DA 202443505-S179B-16 Bentham Street (Section 56 Block 22 Yarralumla)

Yarralumla Residents Association Submission

Figure 1: Proposed Development in Yarralumla & Zoning & developments in progress of 680 dwellings

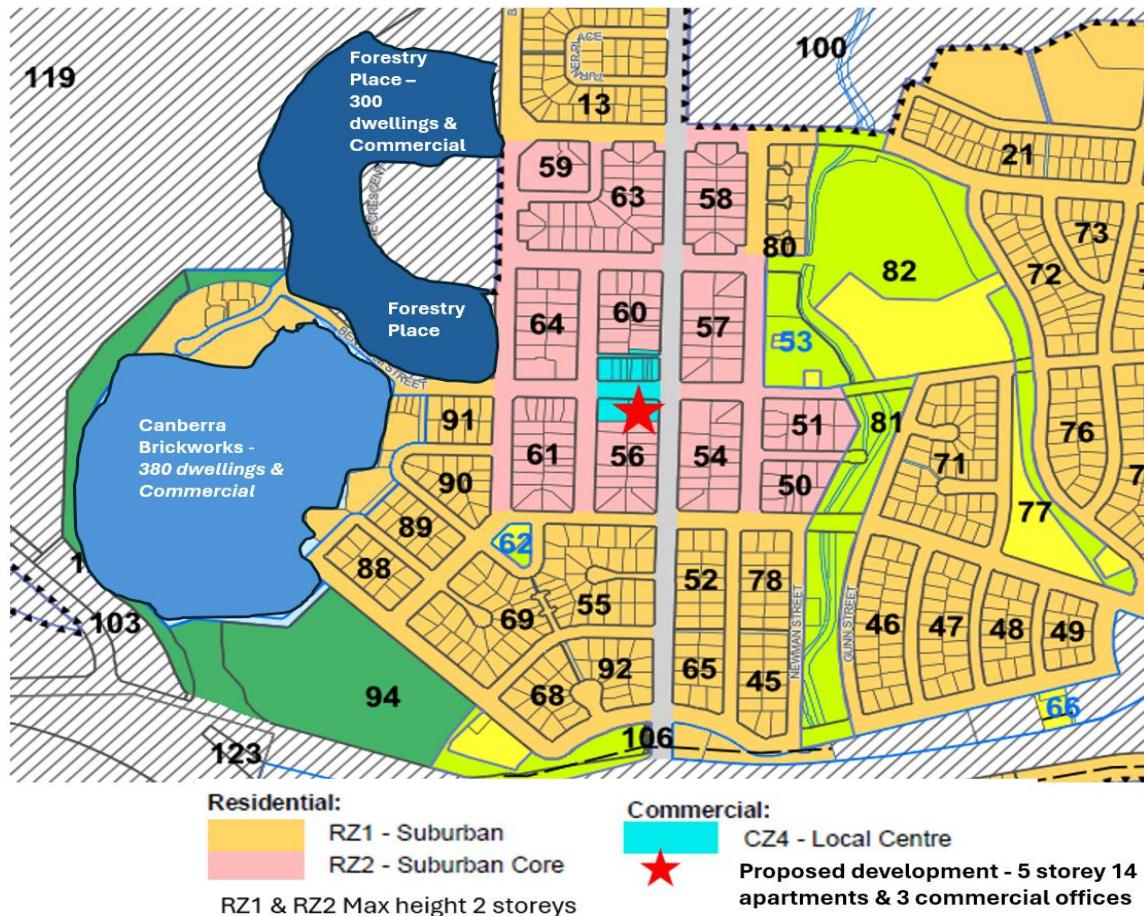
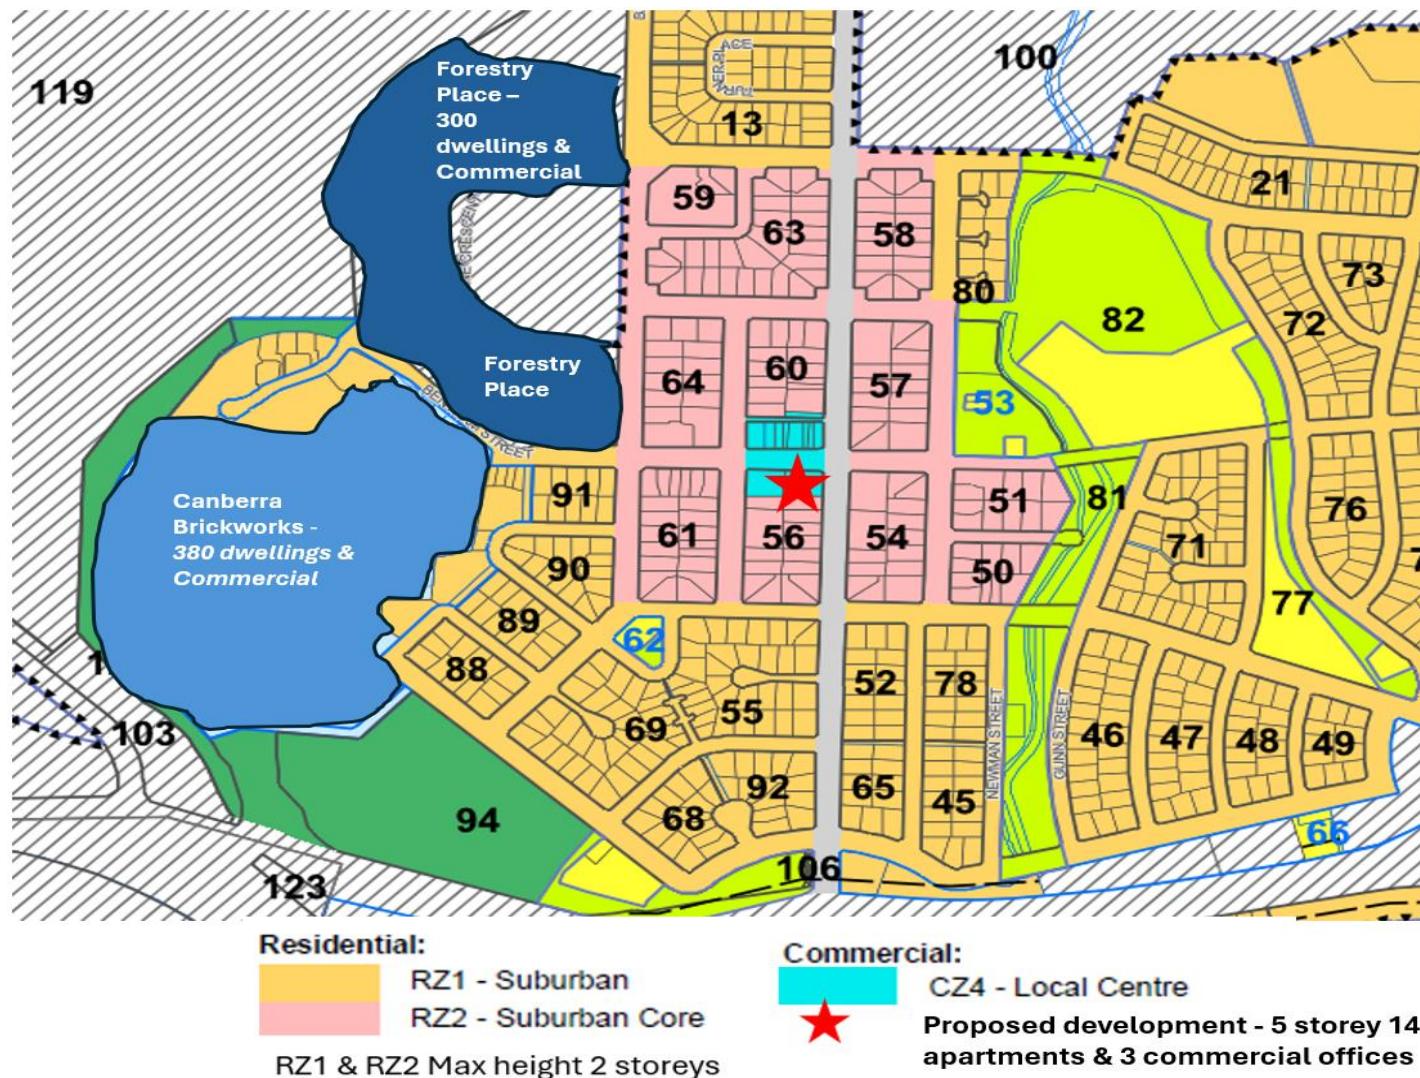
Given the massive infill of Yarralumla of 680 dwellings and commercial premises, currently underway within 200m of the proposed development site, **breaching the requirements for 2 storeys** and the loss of commercial office space from the business centre **cannot be justified**.

2. No justification for 5-storey height in a 2 storey CZ4 zone at a “Local Centre” - non compliant (Figure 1 & Figure 2)

Figure 3: PLAN 20244305-S179B-1 shows 14 of 17 Waste Bins for the 14 Units collected from 39 Novar Street nature strip BUT will actually take up ALL the area to avoid the parking sign and will impact the Regulated Tree

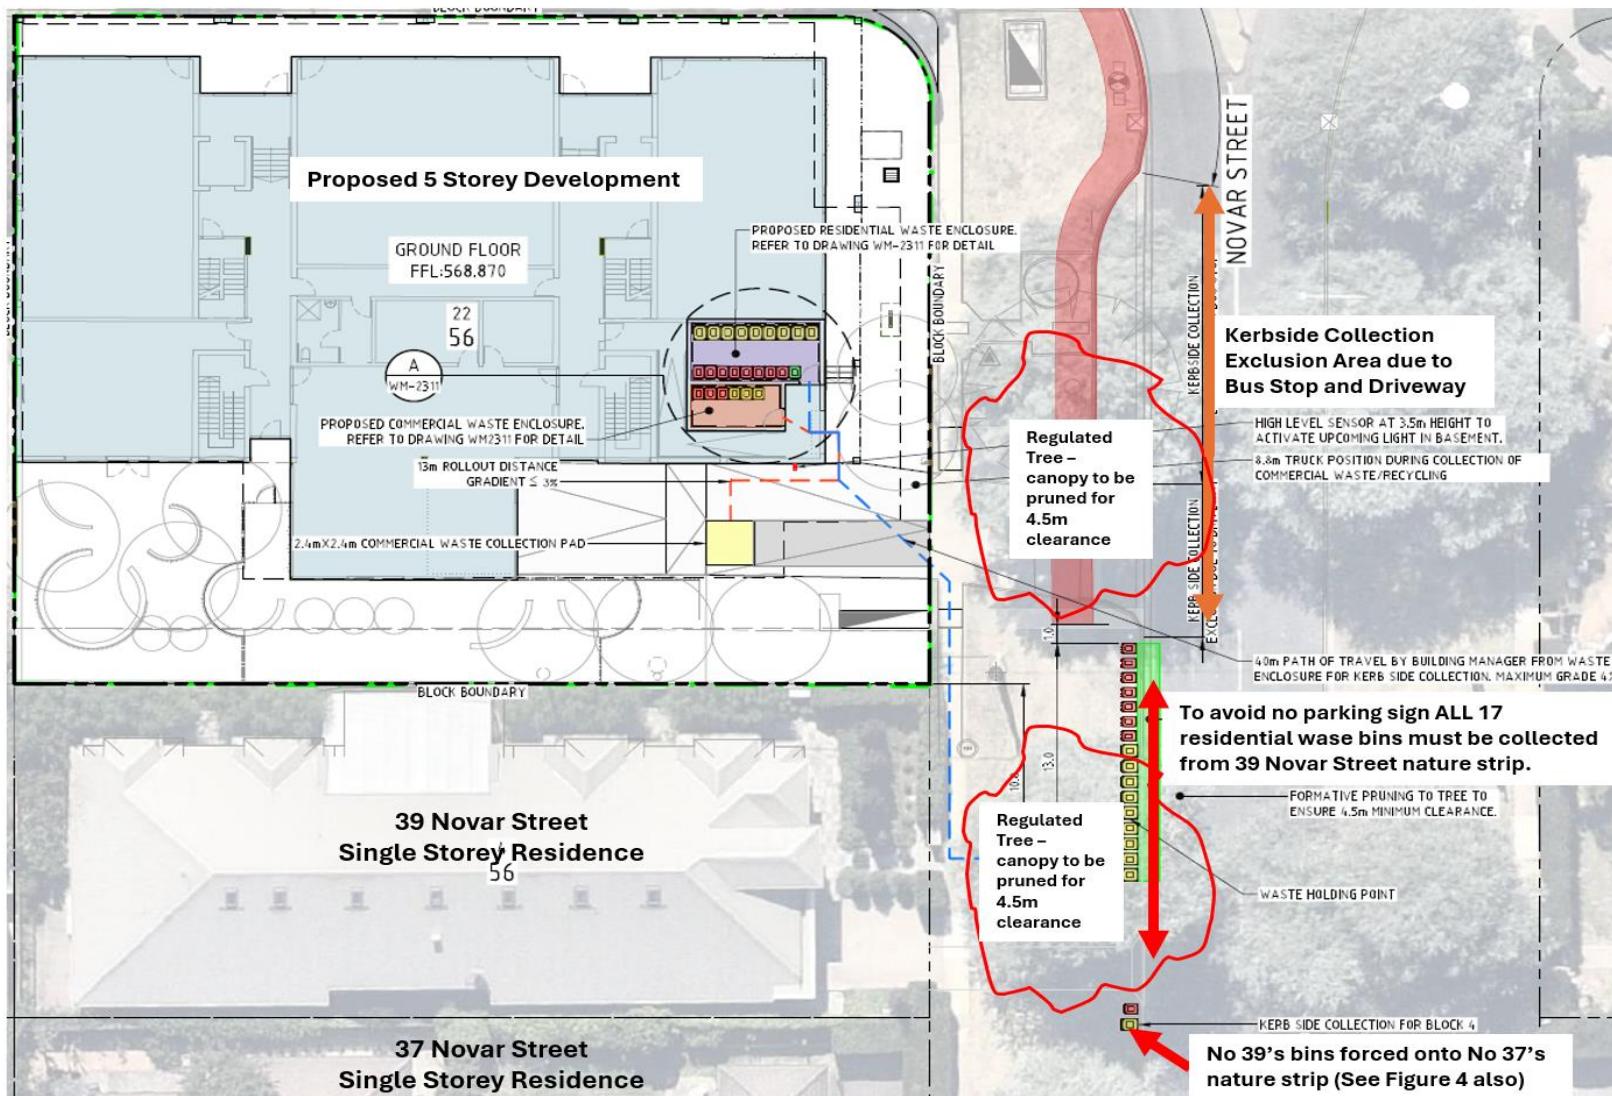
There is insufficient space for the development's residential waste bins and **the information provided is not correct**. The new Waste Report (WASTE-202443505-S178-04) Page 50 has the total set down length of the bins as 13.0m with 10.8m being on the verge of the adjacent property 39 Novar Street but on Page 16 it is 15.3m.

The correct distance required for the 17 bins is a minimum of 15.7m with the 30cm clearance between bins (<https://www.cityservices.act.gov.au/recycling-and-waste/bins>). Under the requirements of the DCCBPWM 2019 the bins cannot be placed next to the no parking sign adjacent

Thus all of the proposed development's bins will be located on the neighbour's nature strip as the available space is constrained to 15.5m because of the property driveway and offset for the parking sign. The available space is minimal if the powerline and regulated tree are also avoided. This leaves no room for the property at 39 Novar Street to place its bins, and indeed the Waste Report diagram already shows one of these bins on the nature strip of 37 Novar Street (Figure 3 and [Figure 4](#)).

The proposed kerbside waste collection is thus non-compliant with the *Development Control Code for Best Practice Waste Management in the ACT 2019* and **has an unacceptable impact on the residence at 39 Novar Street** and its nature strip frontage (Figure 3). This also compromises the property owner's responsibility for the maintenance of their nature strip.

Figure 5: PLAN - TURNTEMPLATE-20244305-S179B-01 Commercial Garbage Trucks turn in Bus Stop Bay and block Basement carpark access

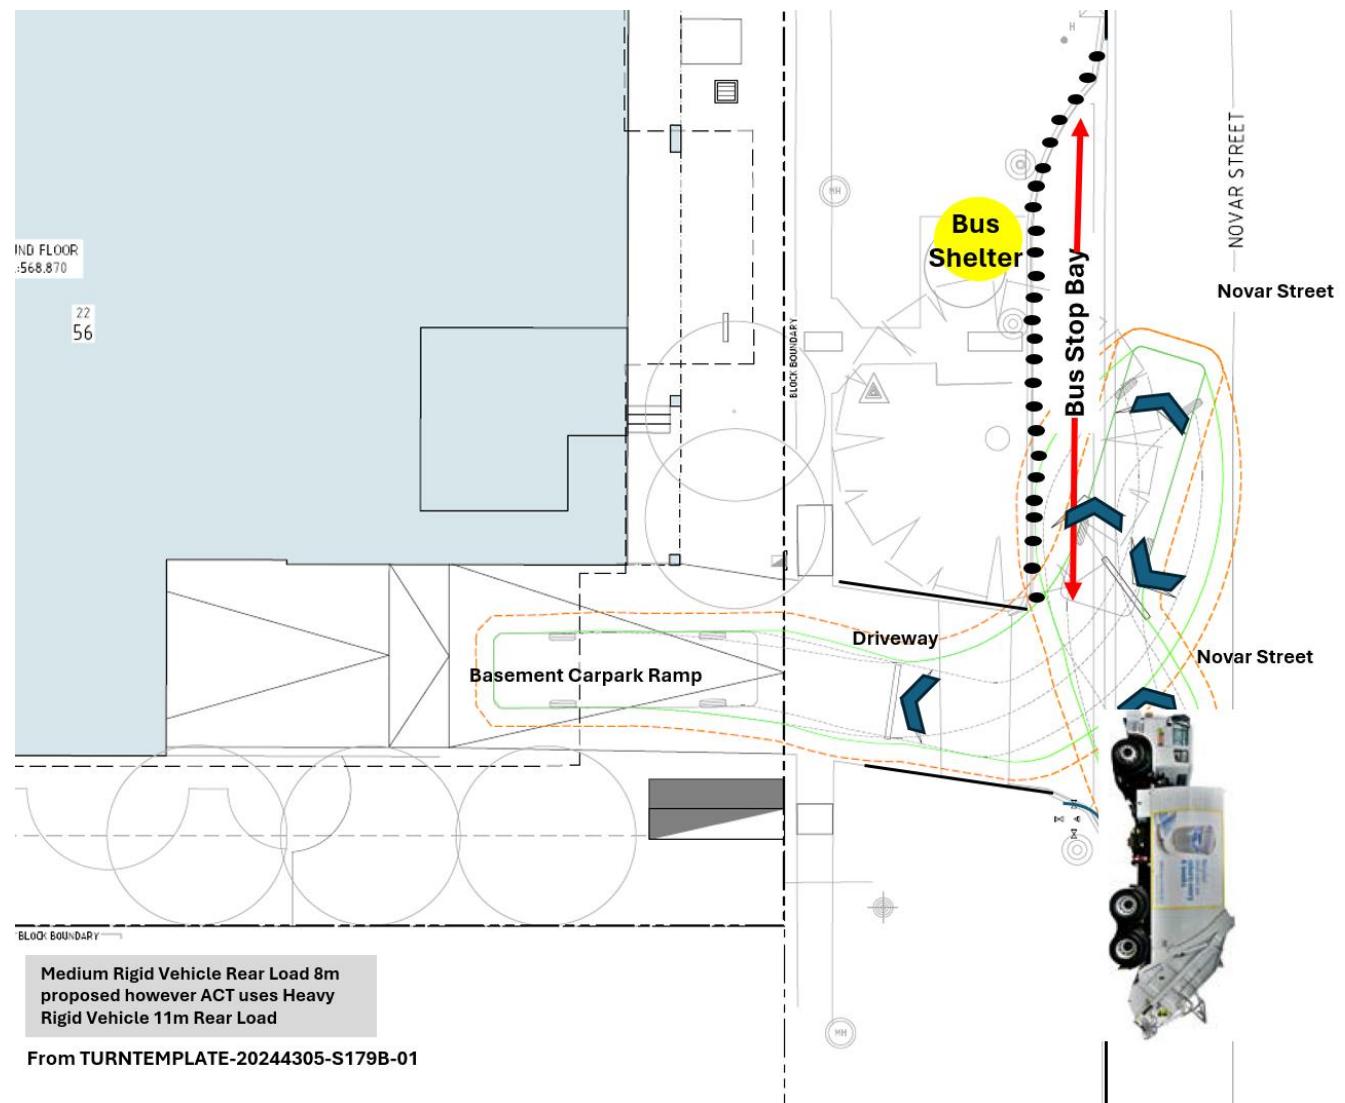
Collection is proposed via the main driveway, with the rear loading 8.8m MRV (Medium Rigid Vehicle) Garbage Truck reversing into the site driveway from the Novar Street Bus Stop Bay, collecting waste and exiting in a forwards direction, both of which are dangerous. The garbage trucks will thus block the Bus Stop Bay set back whilst manoeuvring, and also block vehicle access to the basement carpark ramp by residents (Figure 5 & Figure 6). The driveway access is also adjacent to the Novar and Bentham Street roundabout. **None of these are allowed under the DCCBPWM 2019 PART 7.4.**

The design is not workable as it is based on an 8.8m Garbage Truck which is unavailable in the ACT. In the ACT the Commercial garbage trucks are all 11m rear loaders that require more loading space and more manoeuvring room, would be dangerous to the Bus Stop, and owing to their size would have to park over the 2.4m by 2.4m bin loading pad thereby preventing its use for loading the bins.

Figure 7: PLANS- FLOORREG-20244305-S179B-BASEMENT-01 AND LSCAPE- 20244305-S179B-03

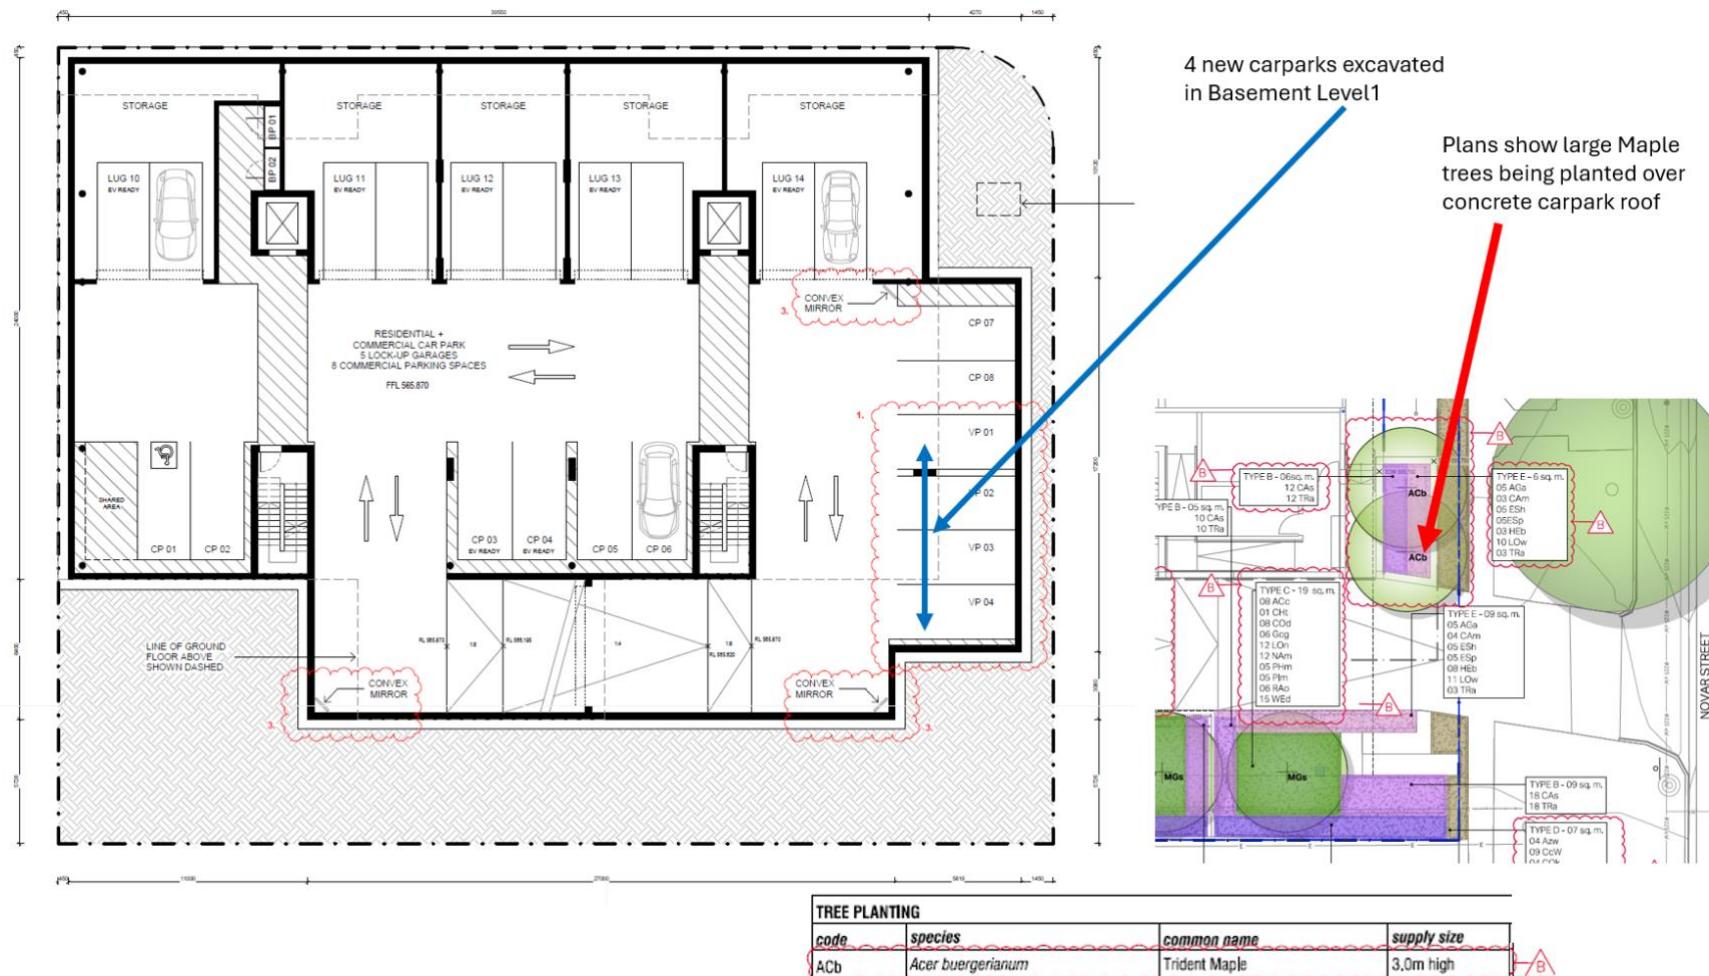
The provision of the 4 additional parking spaces in Basement Level 1 means that **this area of the site allocated for deep root planting can no longer be used for this purpose** as there is a concrete basement under the surface. The Plans (FLOORREG-20244305-S179B-BASEMENT-01 AND LSCAPE- 20244305-S179B-03) still show this area as having trees planted (Figure 7).

The proponent's outcomes response that: *"The proposal provides 27% of the site as deep soil including dimensions necessary for healthy tree growth. There is ample space for canopy trees and increase in permeable ground over existing development" has not been corrected to reflect this reduction.*

Figure 8: Demolition (from Sediment Control Plan)

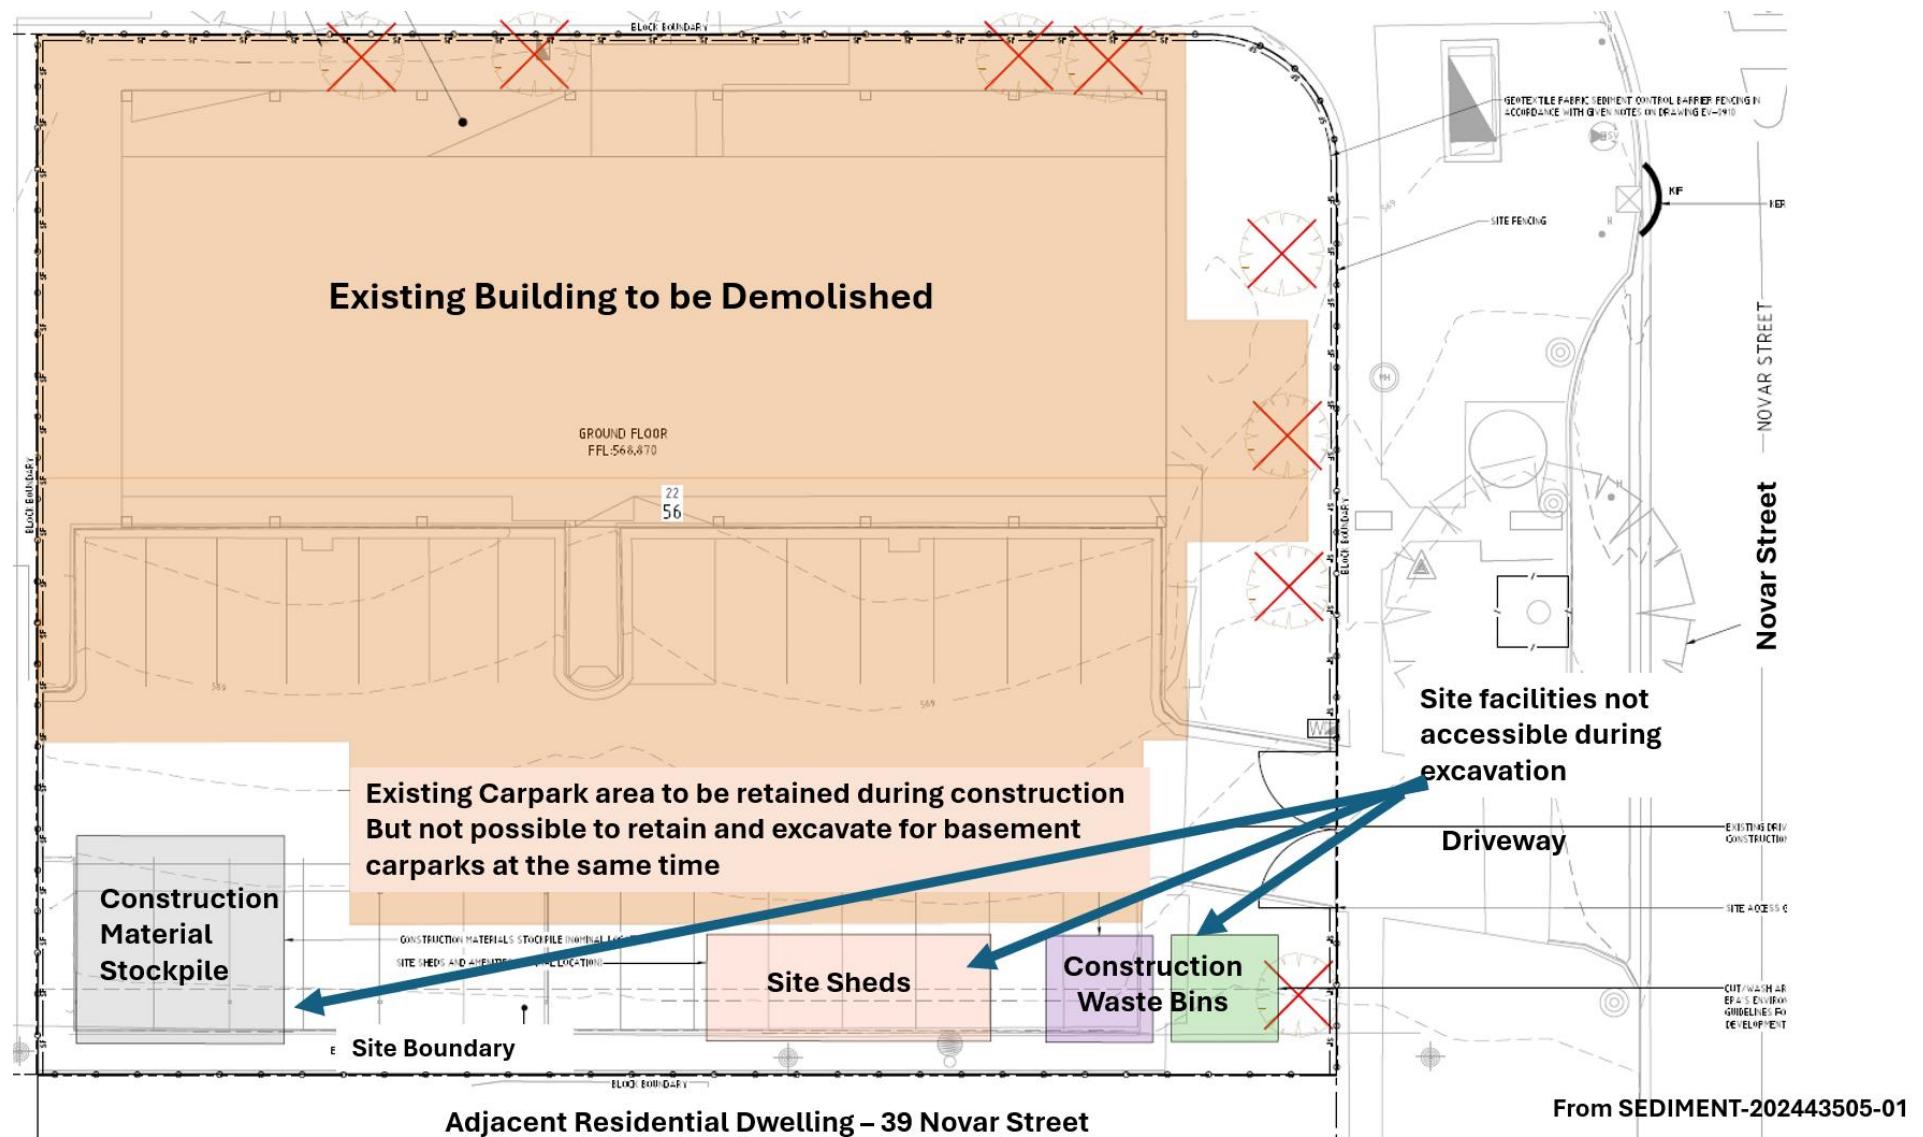
The Plan SEDIMENT- 202443505-1 identifies that the existing carpark area is to be retained during construction, and the construction materials stockpile, construction waste bins and site sheds and amenities are to be located against the boundary of the 39 Novar Street residence with their associated dust, noise and constant activity (Figure 8).

The proposed development requires not only the demolition of the two storey office building and carpark but also the excavation of 85% of the site for the construction of the two levels of basement carparks and access ramps. Thus **it is not possible to retain the existing carpark area and use it for access to stockpile materials, site sheds and construction waste whilst at the same time excavating it for basement carparks** (Figure 8).
